MEMORANDUM FOR: Gus C. Lainas, Chief, Containment Systems Branch, DSS  
FROM: T. M. Su, Containment Systems Branch, DSS  
THRU: J. Kudrick, Section A Leader, Containment Systems Branch, DSS  
SUBJECT: SRV DISCUSSION WITH THE MARK II OWNERS GROUP

Meetings were held on February 16 and 17, 1977, in San Jose, California with representatives of General Electric, Mark II owner group, NRC staff and our consultants (BNL). The minutes of these meetings will be prepared by Sydney Miner, the project manager for Mark II containment. This memo, however, is to apprise you about the discussions held on SRV loadings.

PIPE  
INST.

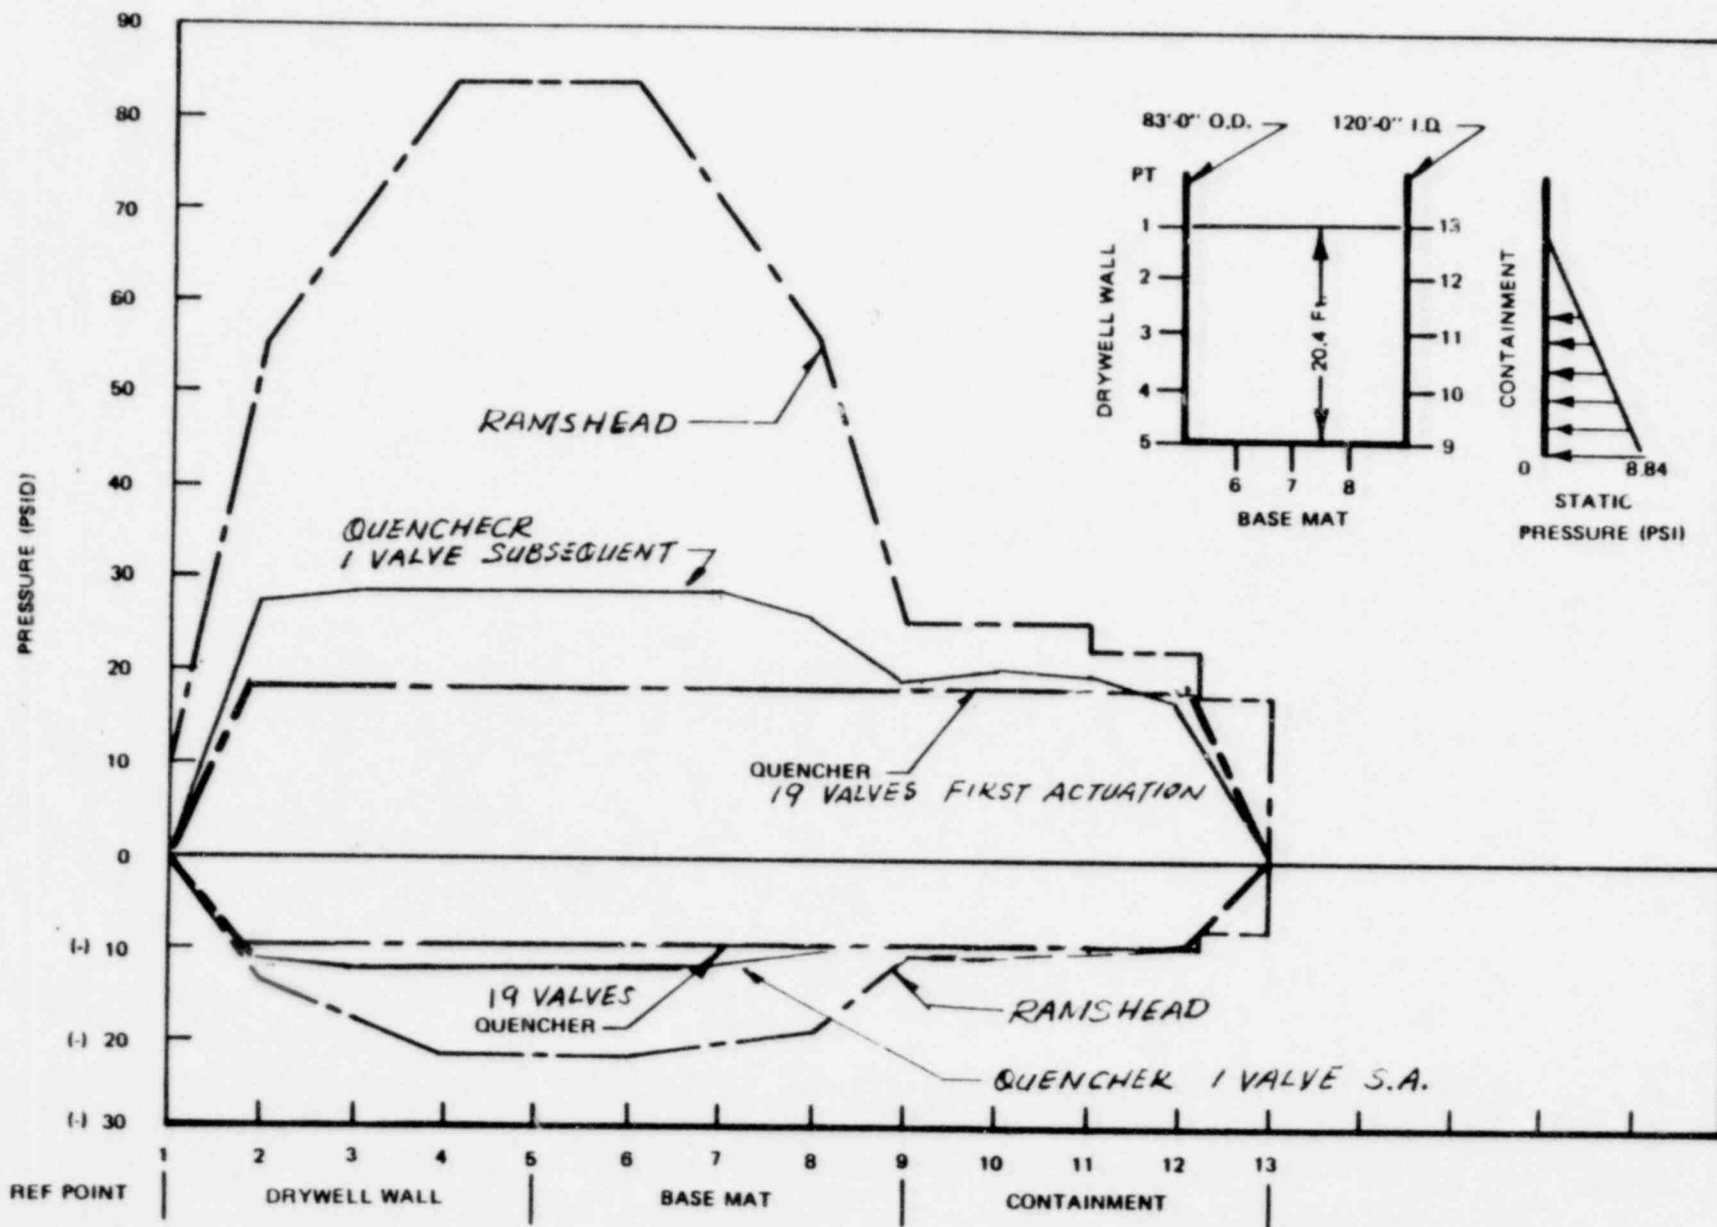
no sequential pops

See pop

only cold pops!

No facing further instruments

Have they  
been repaired?
